Y/55/22/DOC – CONDITIONS 8, 9 AND 10: DRAINAGE RESPONSE

Arun Crematorium

Design Calculations

13591 - Proposed Surface Water Network

Proposed Foul and Surface Water Drainage Layout (Sheet 2 of 2)

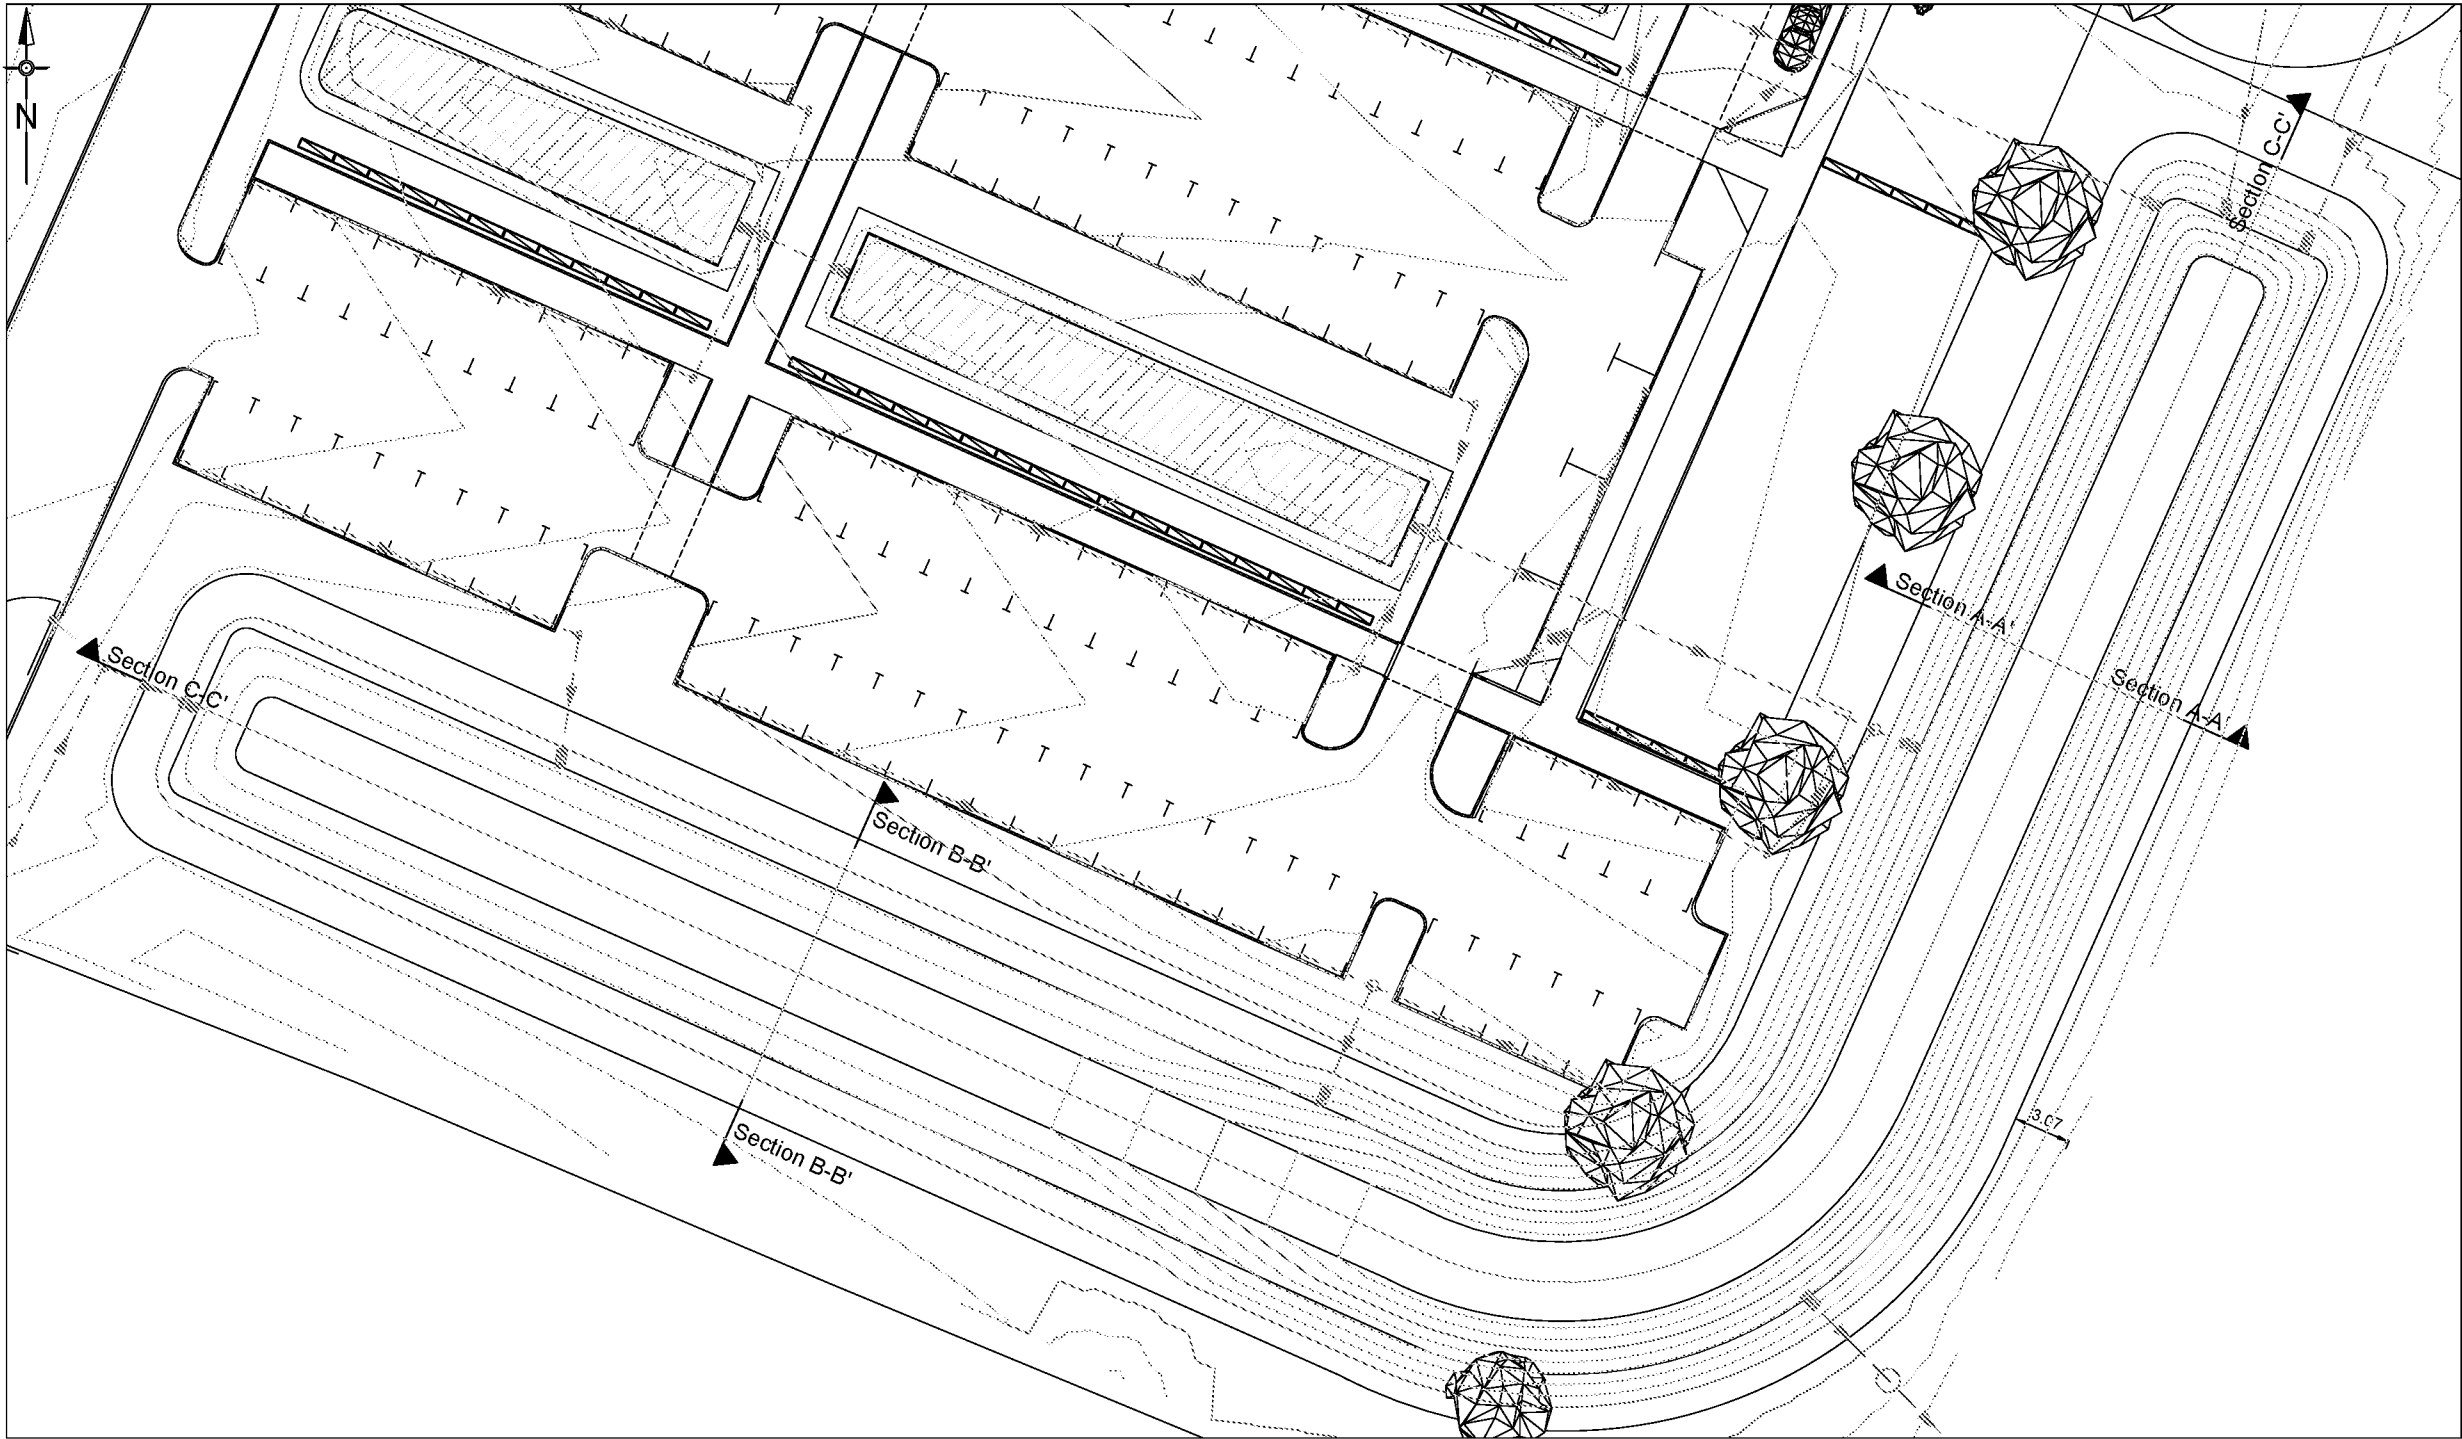
5. *Hydrobrake unit references should be included on layout plans.* Details have been added to updated drainage layout plan 13591-CRH-XX-XX-DR-C-5051 Revision P5 . *Okay, but please see comment above for more detailed calculations to evidence a compliant design. Hydrobrake reference on plans matches the calculations.*

2. Please supply a buffer plan to show that at least 3m is being provided between top of bank of watercourses and obstructing features, such as fences, buildings, and basins. A suitable buffer has been provided between top of basin and edge of watercourse to allow for maintenance, as shown on drawing 13591-CRH-XX-XX-DR-C-5051 Revision P5 . Buffer not clearly shown, please show the buffer on a plan. A buffer has been shown on drawings DR-5050 and 5051 as requested. Okay.

5. Details are shown on the latest drainage layout plan (*13591-CRH-XX-XX-DR-C-5051 Revision P7*).
6. Permeable pavement details can be found in proposed pavement details drawing (*13591-CRH-XX-XX-DR-C-5350 Revision P3*), and formation levels of the porous sub base are shown on the latest drainage layout plans (*13591-CRH-XX-XX-DR-C-5050 Revision P8* and *13591-CRH-XX-XX-DR-C-5051 Revision P7*). Invert levels of fin drains are to be approximately equal to the formation level of sub-base, as shown in pavement detail P2. As the system is unlined and the sub-base is not required for storage, partial infiltration may take place. The fin drains will remove any residual water.

2. A suitable buffer has been provided between top of basin and edge of watercourse to allow for maintenance, as shown on drawing (*13591-CRH-XX-XX-DR-C-5051 Revision P7*).

Drainage Construction Details Proposed Basin Detail Sheet 1 of 2

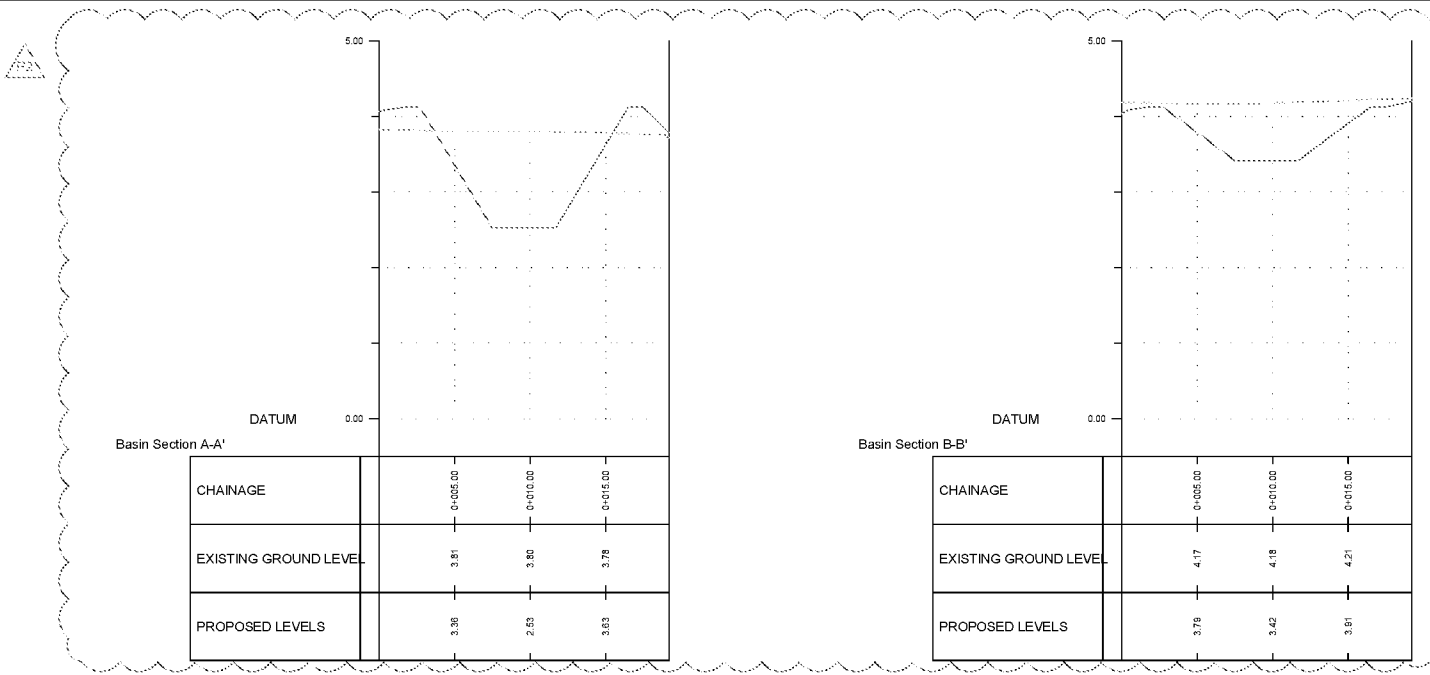
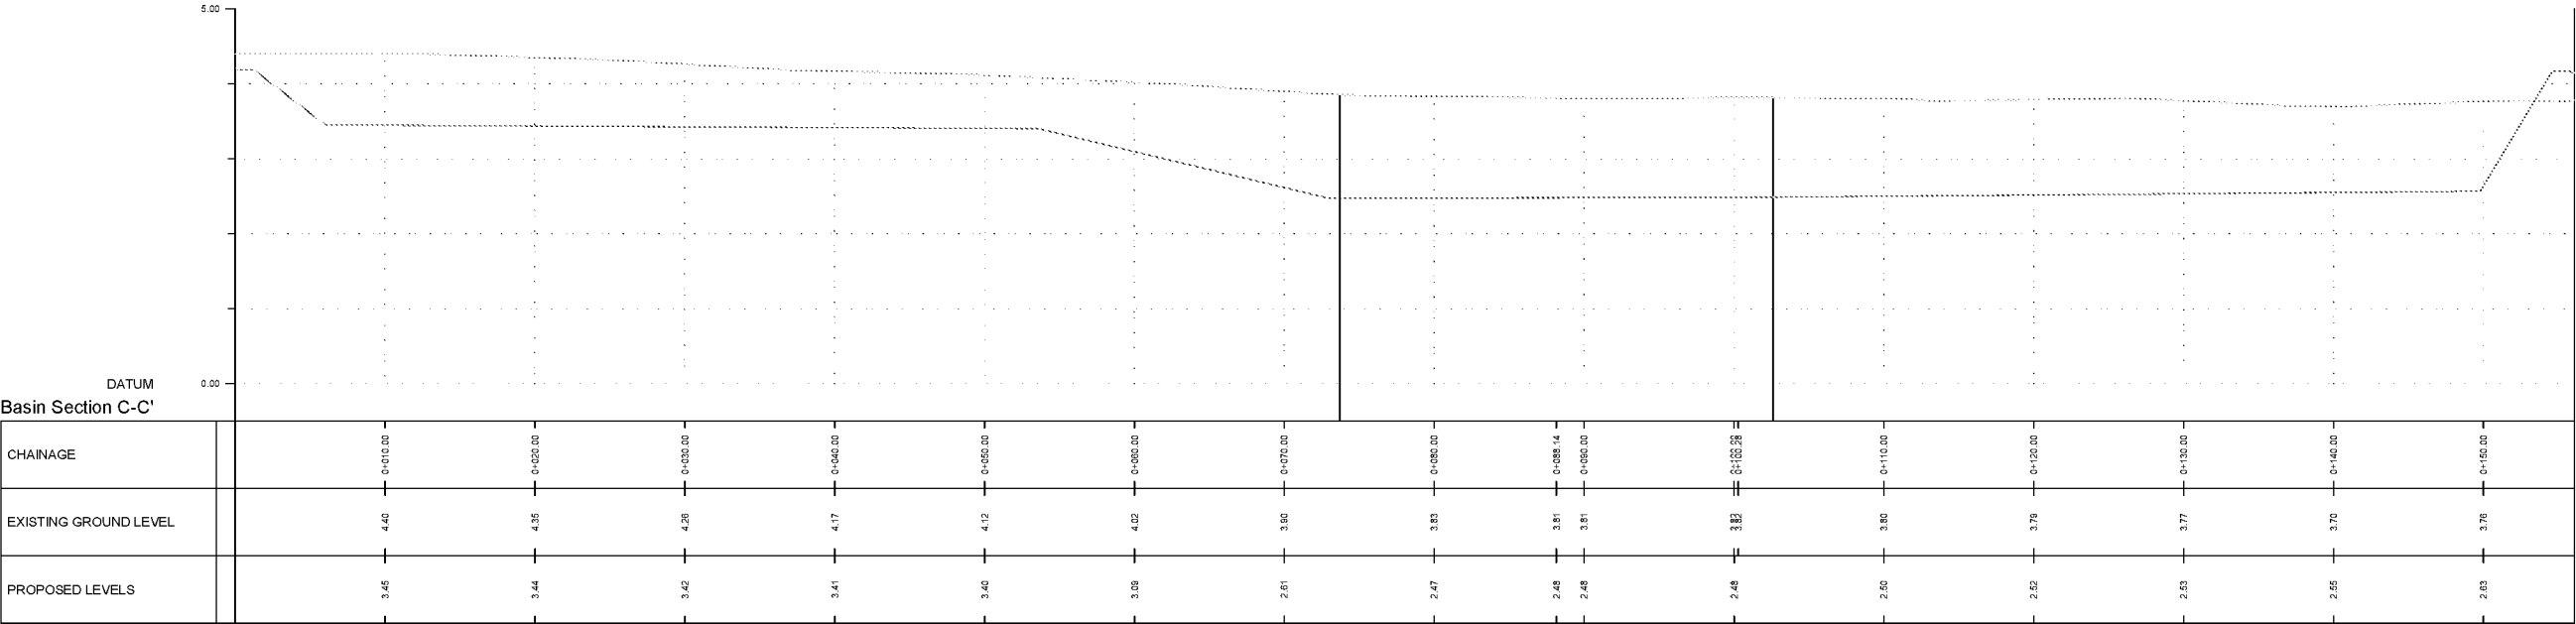
9. Please supply site specific construction details of the attenuation basin, showing invert level, top of bank level, width at bed and width at bank. Please see enclosed basin detail drawing 13591-CRH-XX-XX-DR-C-5310 Revision P1 . To be reviewed once principals are agreed.

9. Please see latest basin detail drawings (*13591-CRH-XX-XX-DR-C-5310 Revision P2* and *13591-CRH-XX-XX-DR-C-5311 Revision P1*).

Detail P2
Permeable block paving construction with fin drain
(Vehicular)

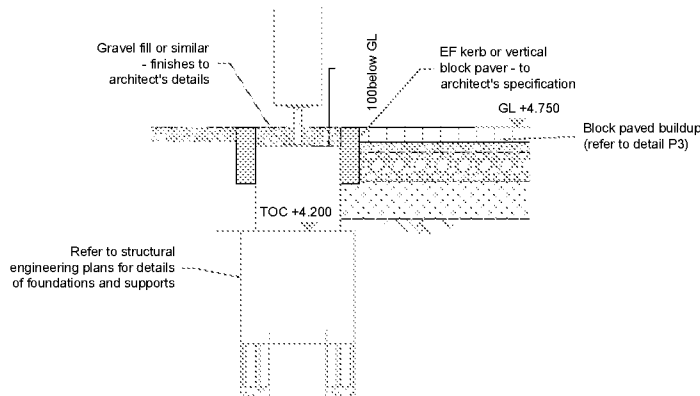
6. *Please label finish and formation level of permeable paving.* Permeable pavement details have been previously provided on detail drawing 13591-CRH-XX-XX-DR-C-5350 Revision P2 . This includes depths of proposed pavement build-up. The proposed surface levels can be obtained from levels plan 13591-CRH-XX-XX-DR-C-5200 Revision P3 and sub base levels inferred (Minor updates to Revision P3 enclosed for completeness). *Finish and formation levels of permeable paving must be detailed, thank you for providing a finished levels plan, please provide formation levels on layout plan, this is required to evidence adequacy of proposed connections from permeable paving. And to ensure correct construction. Formation levels of porous sub base of permeable paving have been added in green text to drawings DR-5050 and 5051 as requested. Formation levels do not match modelled invert levels or slopes. Please label invert levels of fin drains.*
